**Economic Commission for Europe****Inland Transport Committee****Working Party on Inland Water Transport****Working Party on the Standardization of Technical  
and Safety Requirements in Inland Navigation****Fifty-sixth session**

**Promotion of River Information Services and other Information  
and Communication Technologies in inland navigation:  
the International Standard for Tracking and Tracing  
on Inland Waterways (resolution No. 63, revised)****Amendments to the International Standard for Tracking and  
Tracing on Inland Waterways (annex to resolution No. 63,  
revised)****Transmitted by the Chair of the International Vessel Tracking and  
Tracing (VTT) Expert Group\*****Mandate**

### Amendment proposal to the annex to resolution No. 63, revised, “International Standard for Tracking and Tracing on Inland Waterways (VTT)”

**Figure 3.1**

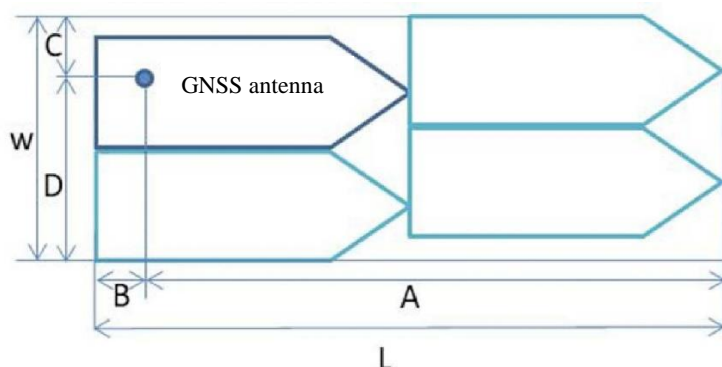
After the table, add

**Reference point for reported position and overall dimension of the vessel/convoy**
